1st Further Information

**Proposed Temporary Warehouse (Excluding Dangerous Goods Godown) with Ancillary Facilities
and Associated Filling of Land for a Period of 3 Years in "Agriculture" Zone,
Various Lots in D.D. 107, Fung Kat Heung, Kam Tin North, Yuen Long, New Territories**

(S.16 Planning Application No. A/YL-KTN/1266)

Responses-to-Comments

Fig.1

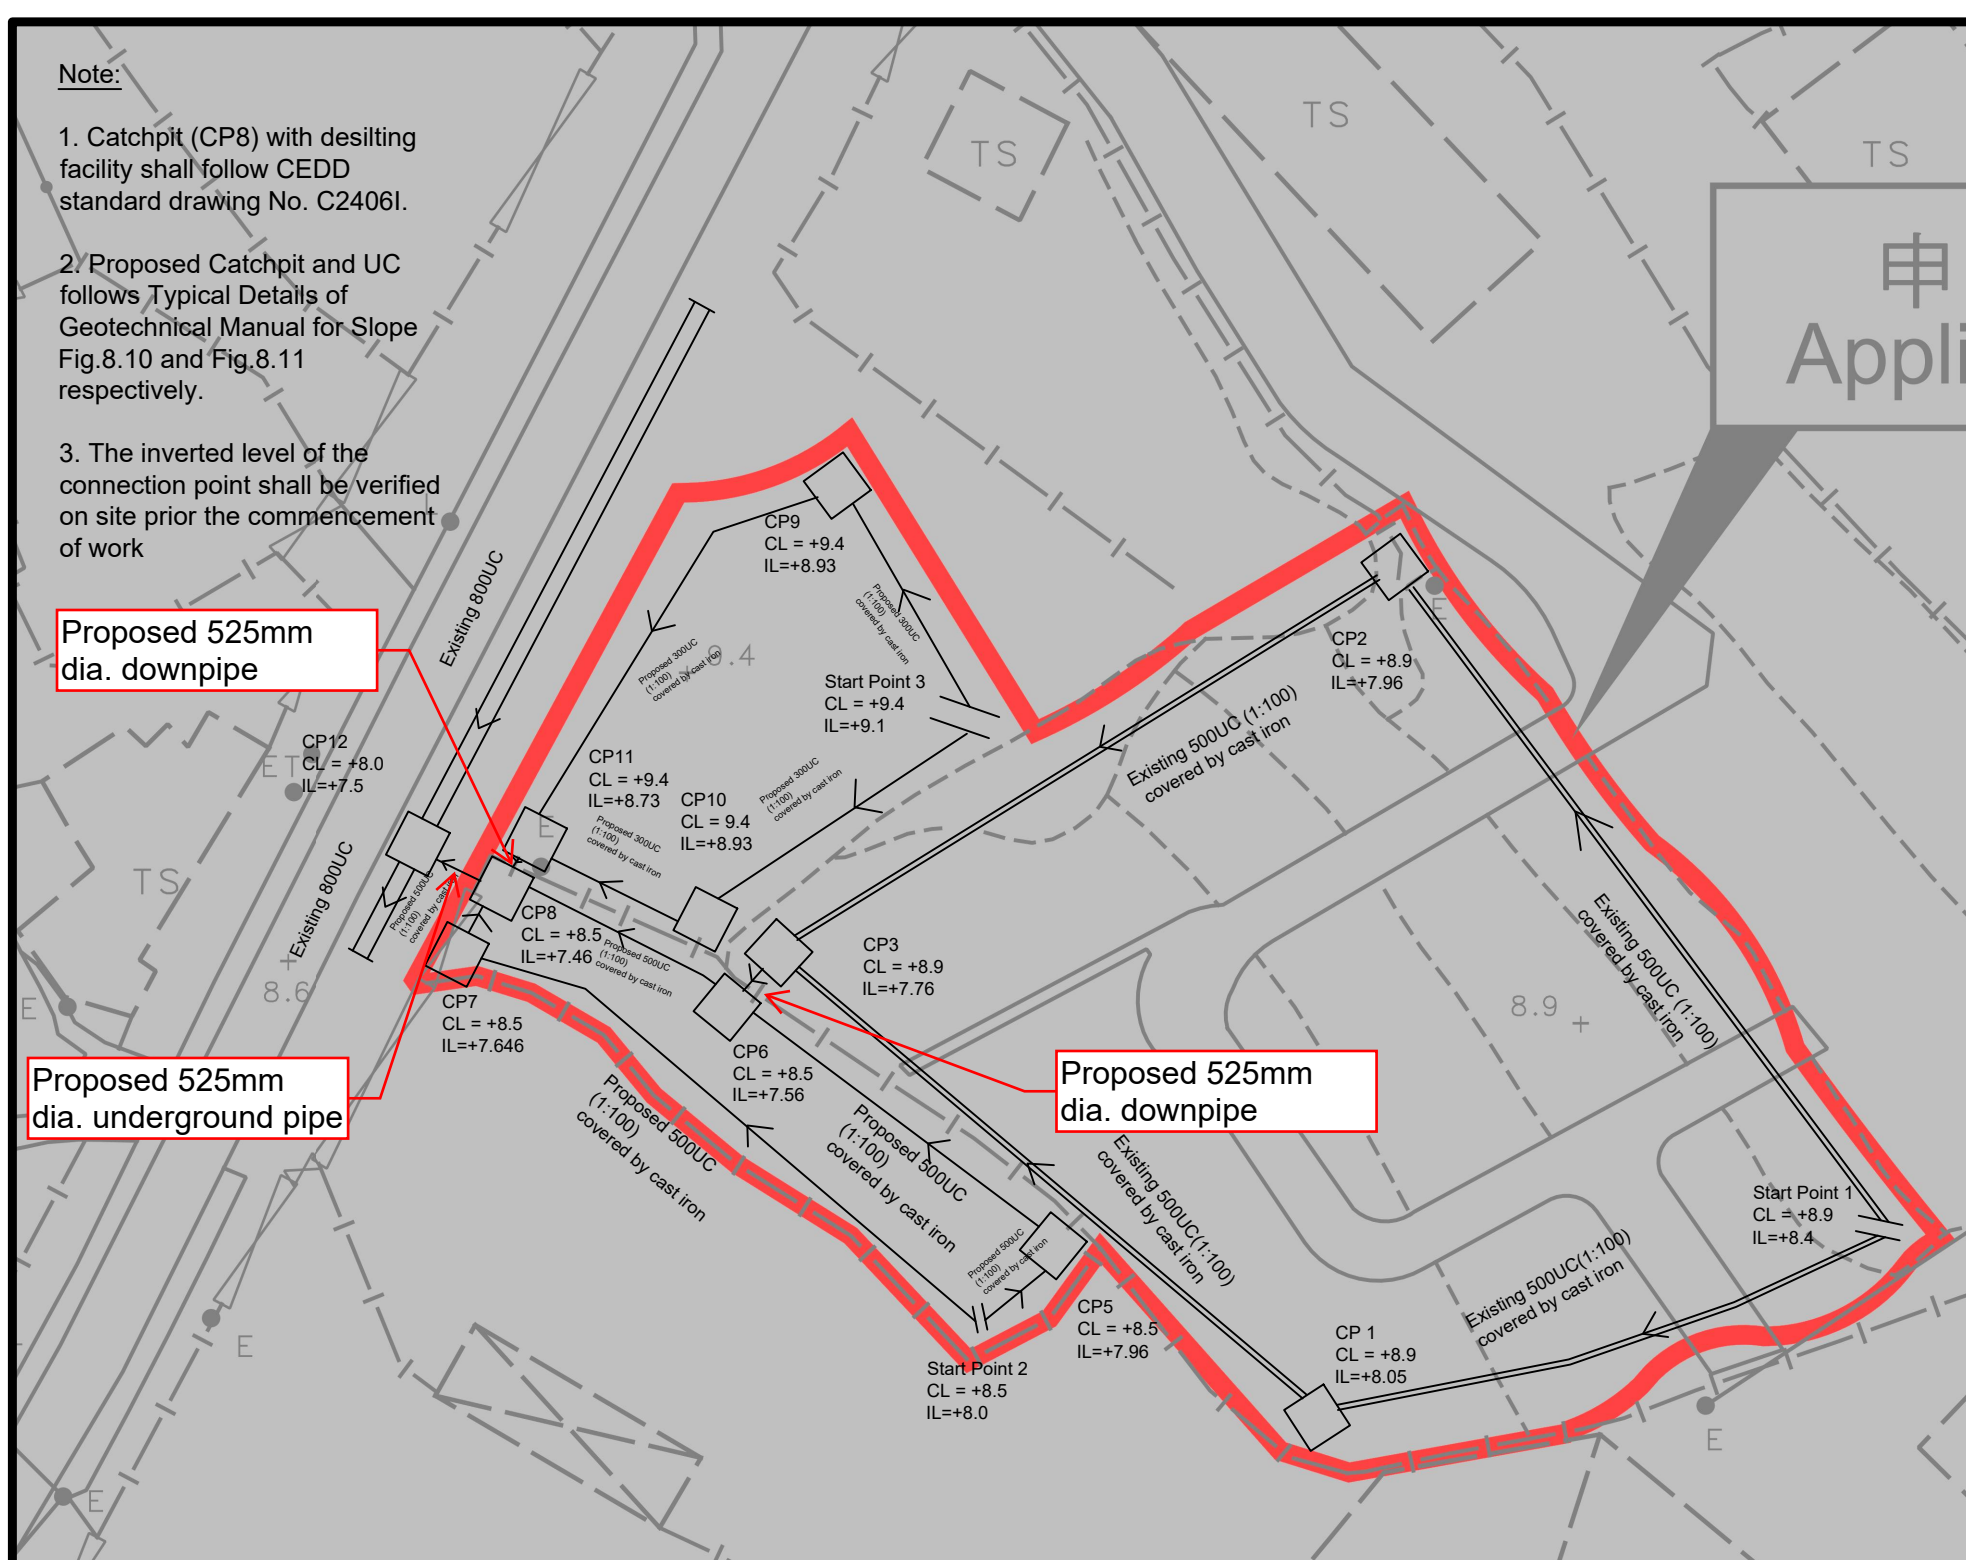
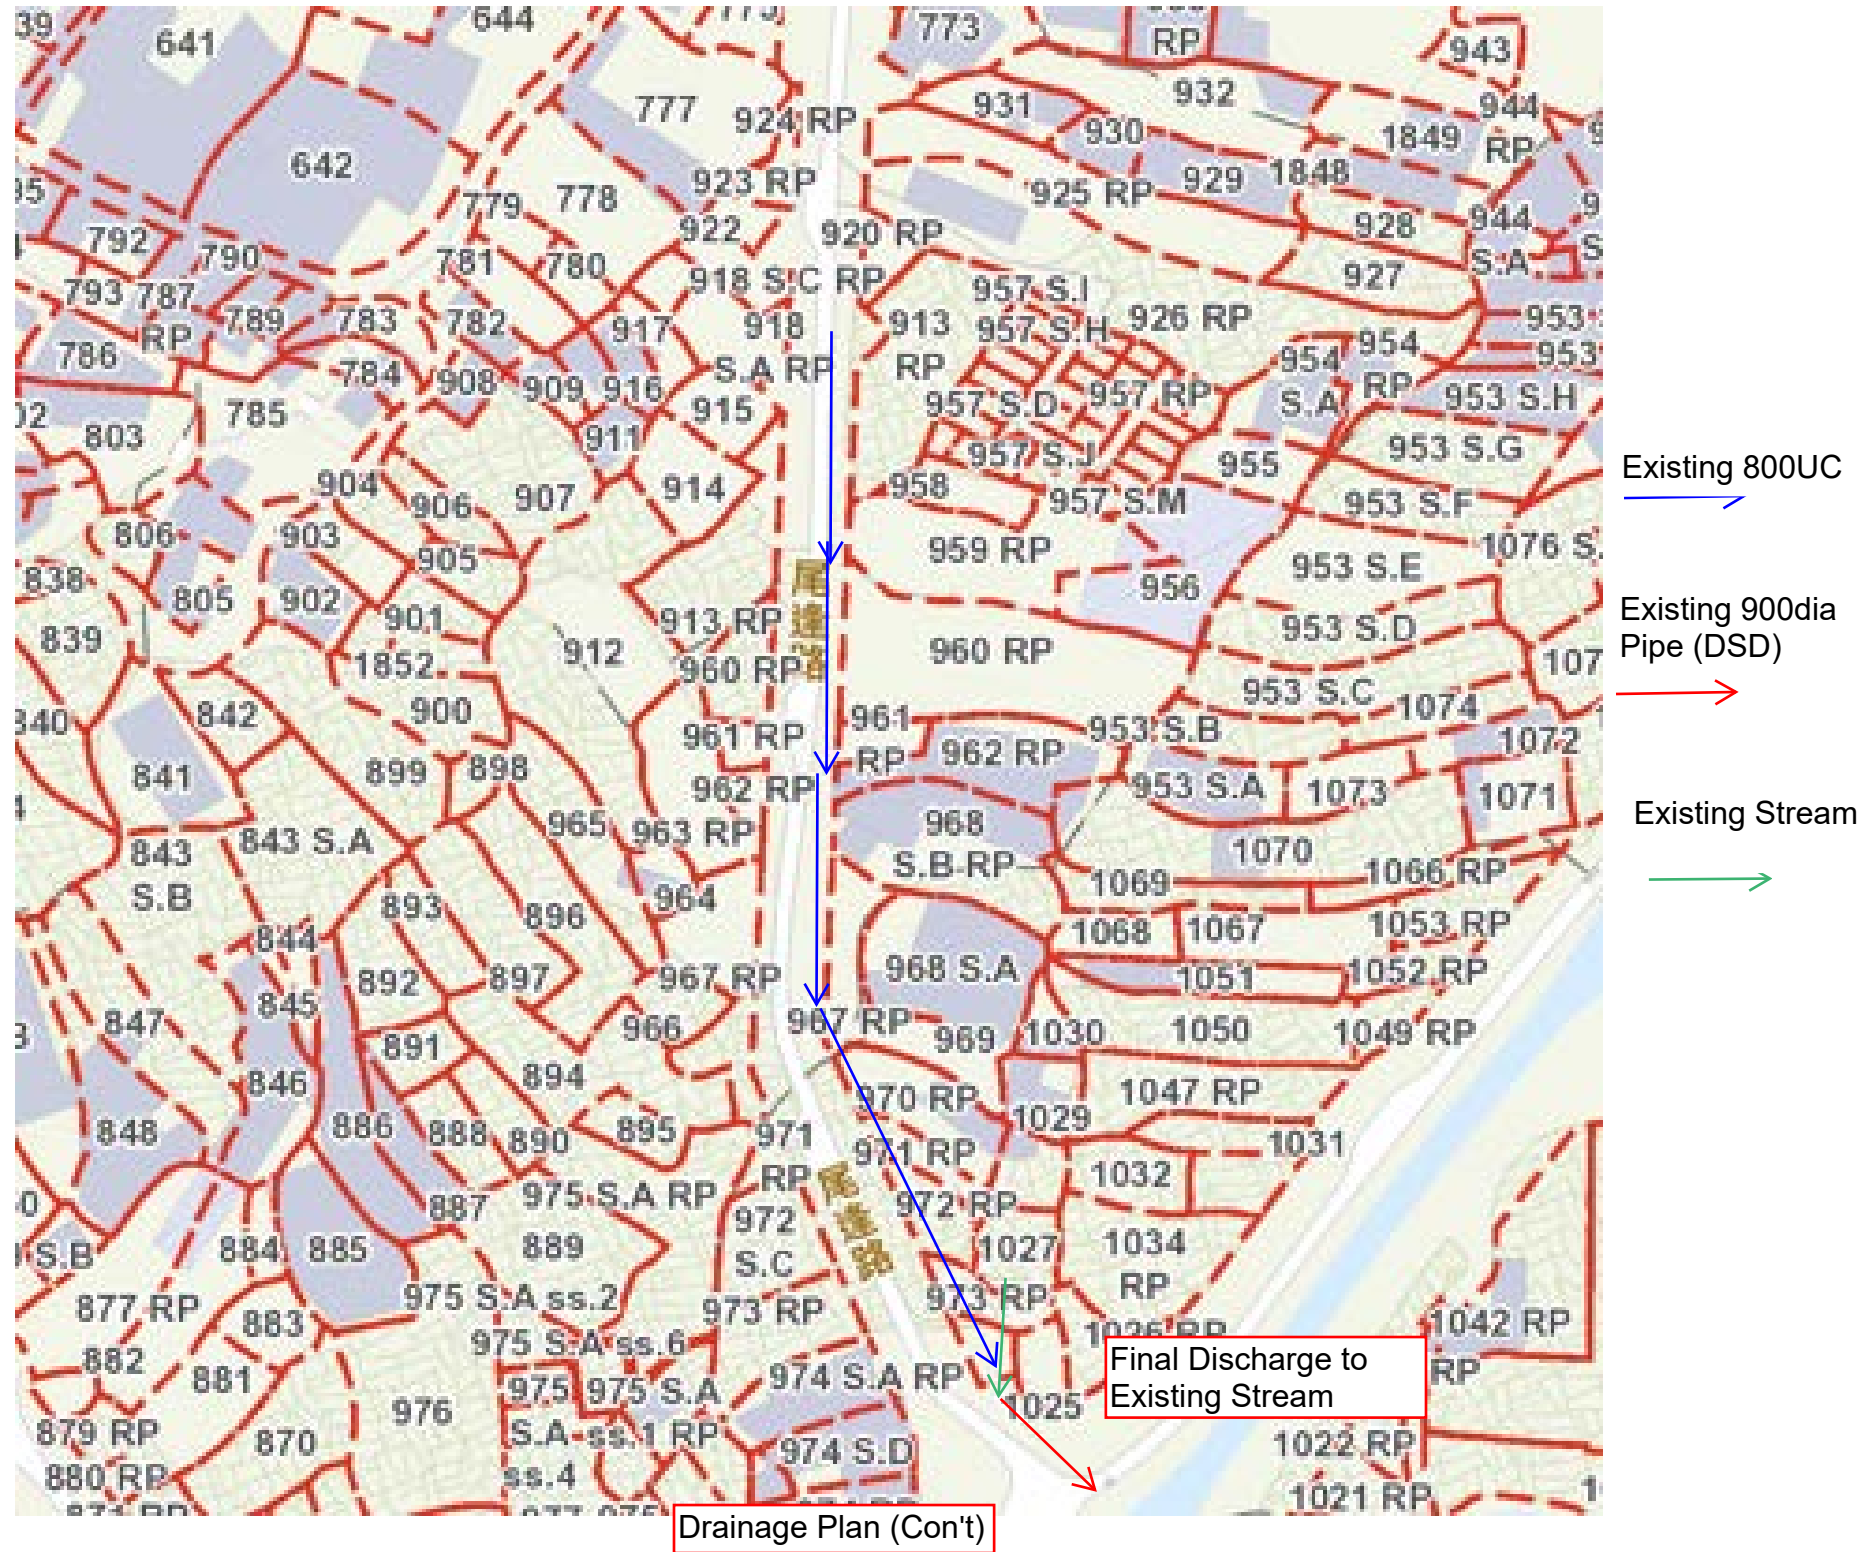
(2)	The applicant should clarify name, cover level and invert level of existing catchpit at the downstream of the proposed catchpit CP8. Invert levels of drainage facilities at the upstream should be higher than that at the downstream.	The catchpit at downstream stream of CP8 has been renamed as CP12 (Appendix II).

1. Catchpit (CP8) with desilting facility shall follow CEDD standard drawing No. C24061.

3. The inverted level of the connection point shall be verified on site prior the commencement of work

Legend: Proposed UC (Gradient) with cast iron cover Existing Drain Proposed Catchpit	
Company:	
Project: Various Lots in D.D. 107, Fung Kat Heung, Kam Tin, Yuen Long, New Territories (A/YL-KTN/1266) (Drainage Proposal)	
Title: Catchment Zone	
Dwg No:	File:
Fig.2	
Date: 8 May 2025

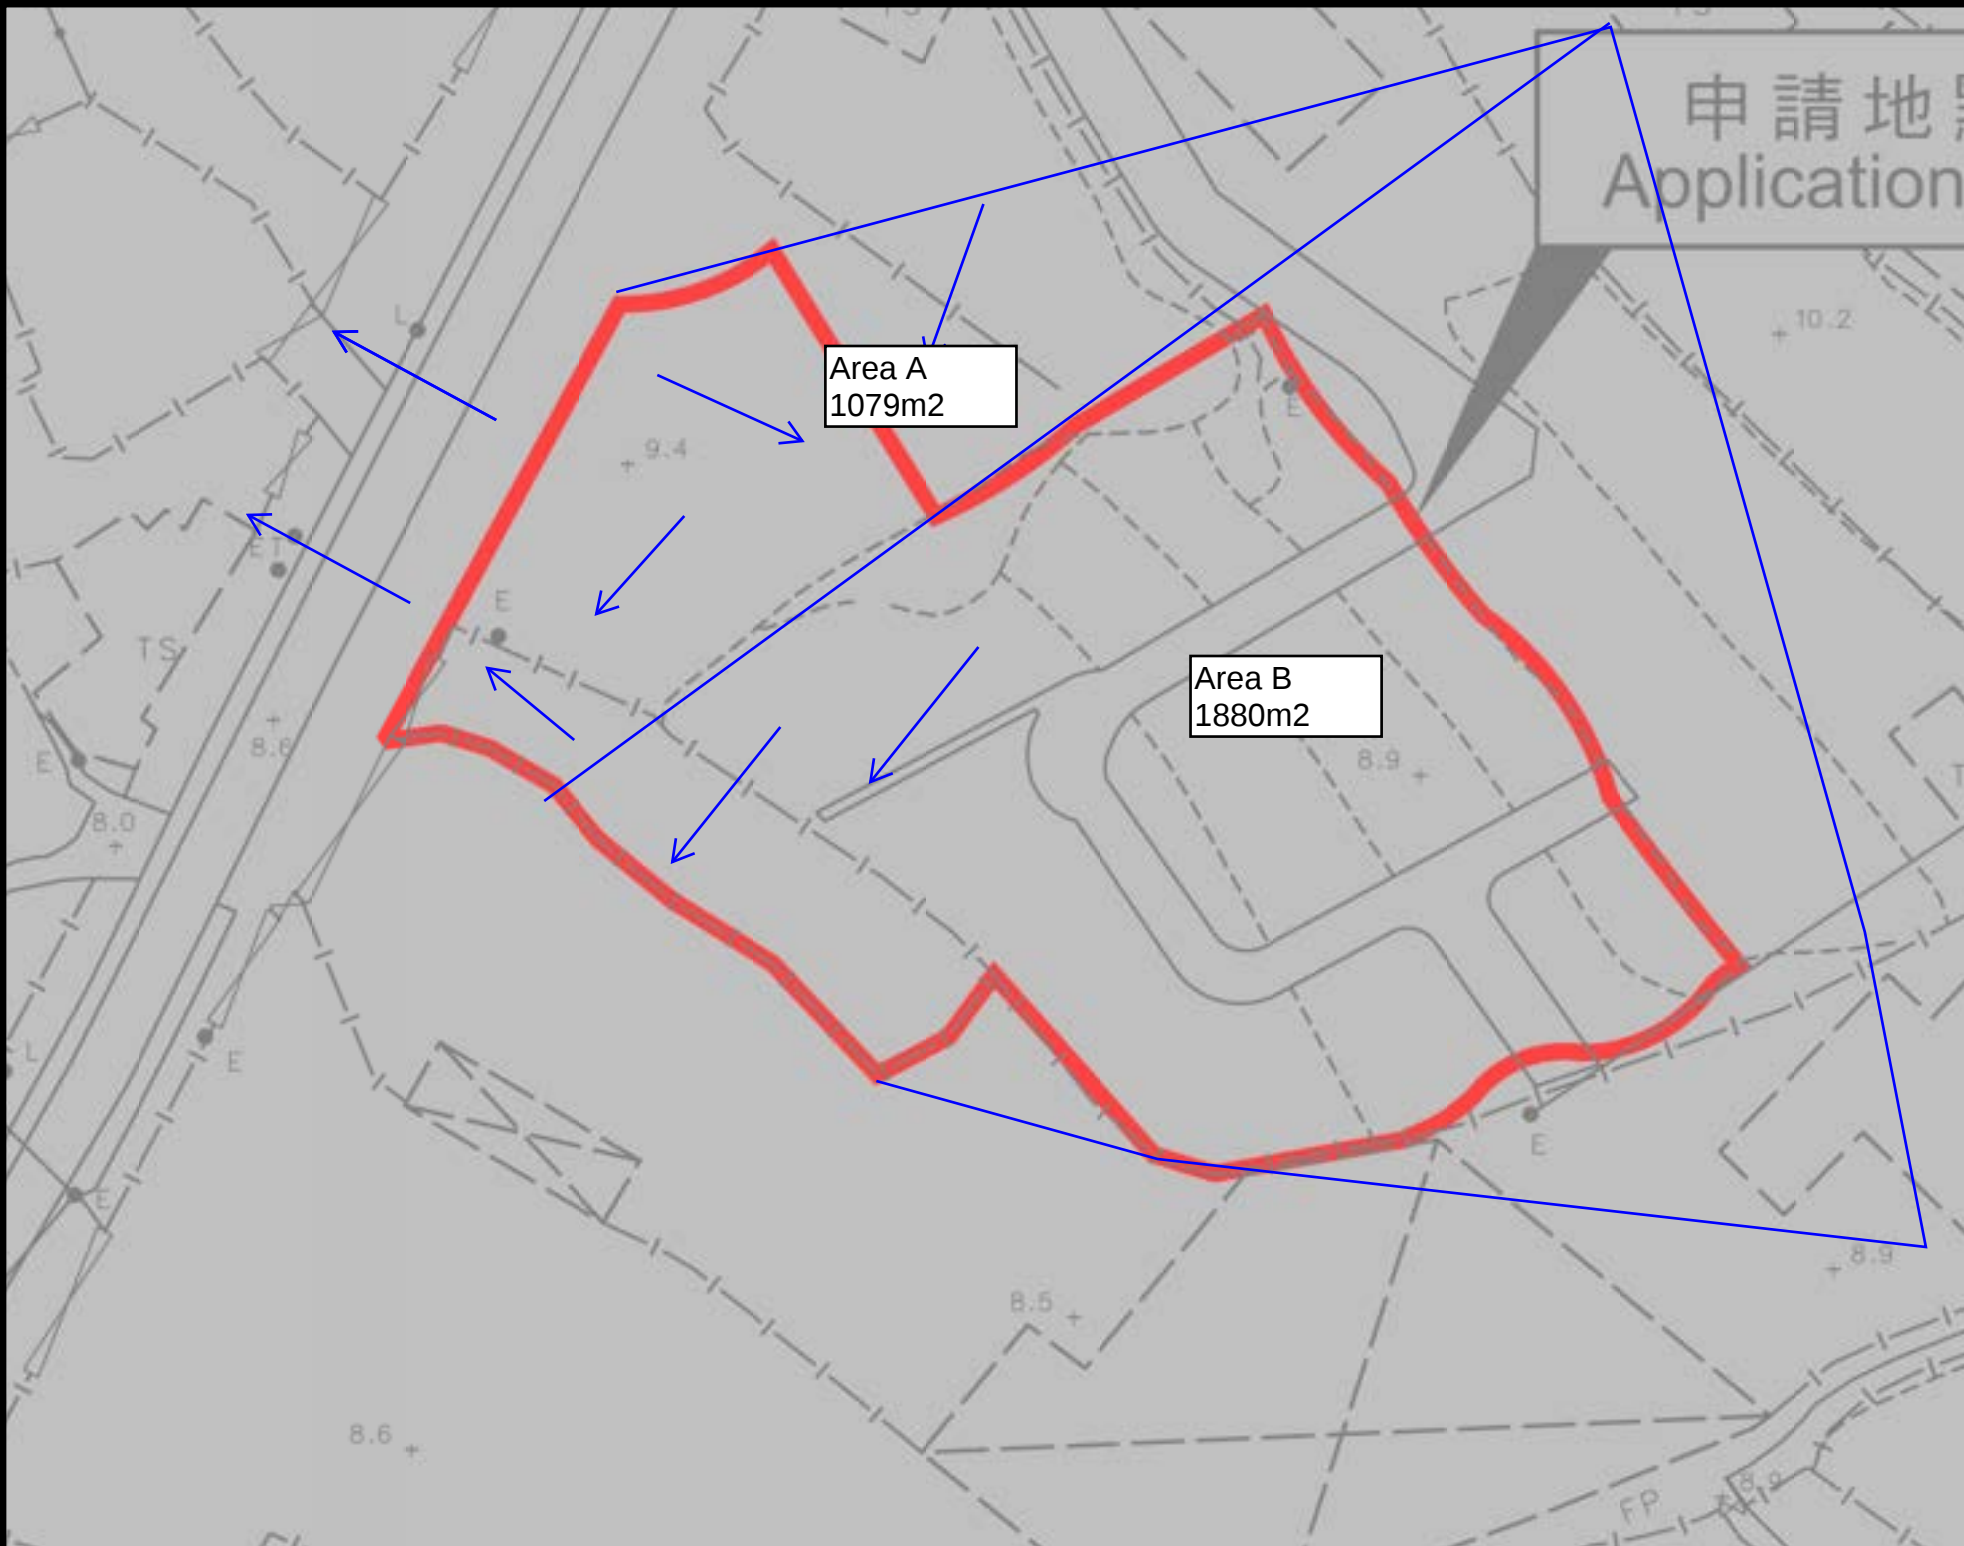
(1)	For design checking of the existing drainage facilities, paved area assumed in the submitted hydraulic calculation is underestimated. The applicant should review paving ratio adopted in the submitted hydraulic calculation.	Noted. The paving ratio and paved area has been calculated. All hard-pave area is 7500 sqm ($7500/31112.2 = 0.3$) which is occupied one-third of catchment area (Appendix II).

All hard-pave area is 7500 sqm ($7500/31112.2 = 0.3$) which is occupied one-third of catchment area`

Total hard-paved area
= $800 \times 3 + 500 \times 5 + 1000 \times 2 + 750 + 600$
= 7500sqm

Ratio of hard-paved and soil-paved = 1:3
Catchment Area = 31113m²

Coefficient of runoff
= $[0.95(1)+0.25(3)] / (1+3)$
=0.43

$Q = 0.278 C i A$
= $0.278(0.43)(266)(31113 \times 10^{-6})$
= $0.9866 \text{ m}^3/\text{s}$
= 59636 lit/min
